Affected Date Code: **02/28/2023**

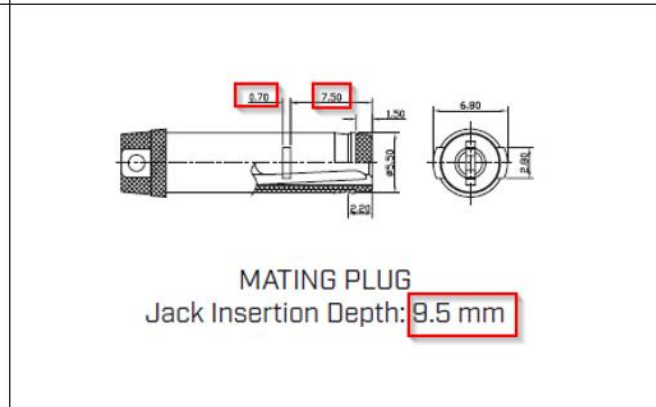
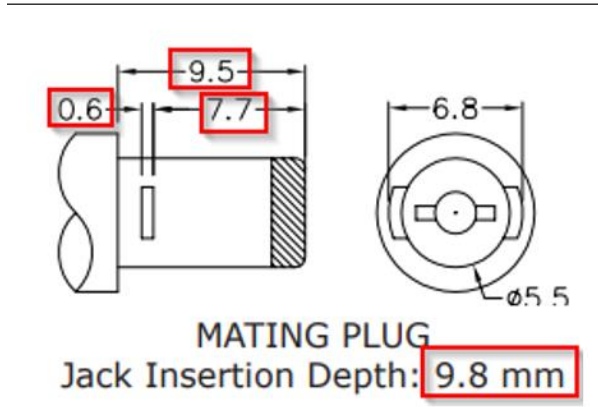
PREVIOUS CUI DEVICES DETAIL / IMAGE			NEW CUI DEVICES DETAIL / IMAGE		
	MATERIAL	PLATING	DESCRIPTION	MATERIAL	PLATING/COLOR
center pin	copper	nickel	center pin	brass	nickel
terminal 1	brass	silver	terminal 1	brass t=0.30	silver
terminal 2	copper alloy	silver	terminal 2	bronze t=0.25	silver
terminal 3	brass	silver	terminal 3	brass t=0.30	silver
plastic	PBT		cover	PBT (UL94V-0)	black
			housing	PBT (UL94V-0)	black
